Council Ref: MOD2016/0035  
(Modification of DA 2014/0098)

**FOLLOW UP ADVICE: SECTION 96 MODIFICATION 2016/0035, MAX. DAILY TRUCK NUMBERS, SHERIDAN'S  
HARD ROCK QUARRY Pt. LOT 62 & 63 IN DP 752807, No.242 FAHEYS & BULGINS ROAD, HERNANI NSW**

FIGURE 1: Passing Bay No. 1

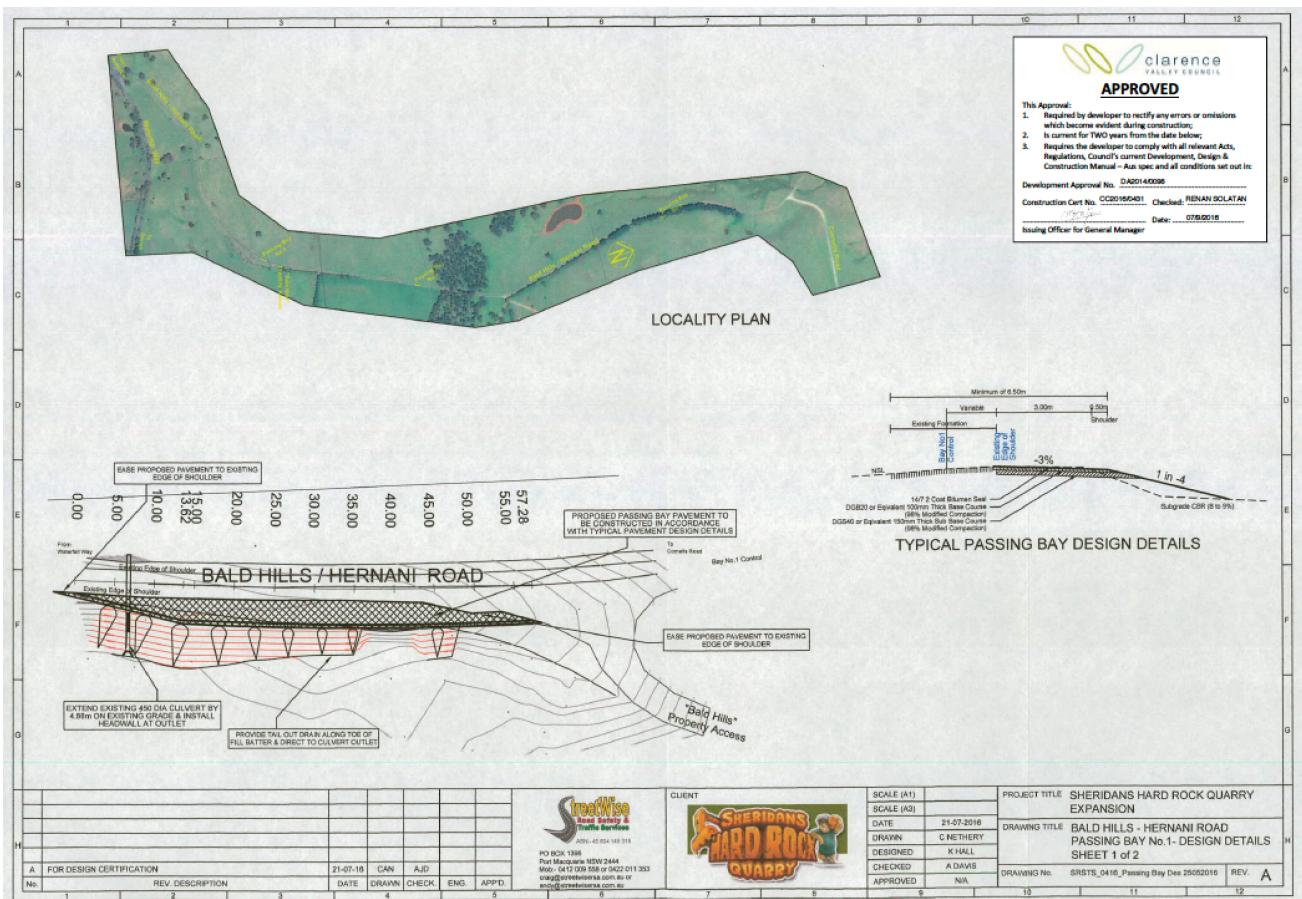
A Completion Certificate issued by consulting engineers Geoff Slattery and Partners on 21 October 2016. It was noted in this report that despite the design allowing for a pavement 250mm thickness sub-grade issues at various locations resulted in a thicker pavement being placed, as follows:

- Passing bay 1 depth greater than 350mm.
- Passing bay 2 depth greater than 450mm.
- Passing bay 3 depth greater than 500mm.

Density tests of the pavement were carried out by AC Testing Services. Refer to accompanying **Figures 1-3**, showing the design for each of the (Council-approved) passing bays. Refer to advice to Council dated 15 September 2016 regarding surrender of the consent DA201/0358 following completion of construction of the passing bays- **Attachment E**.
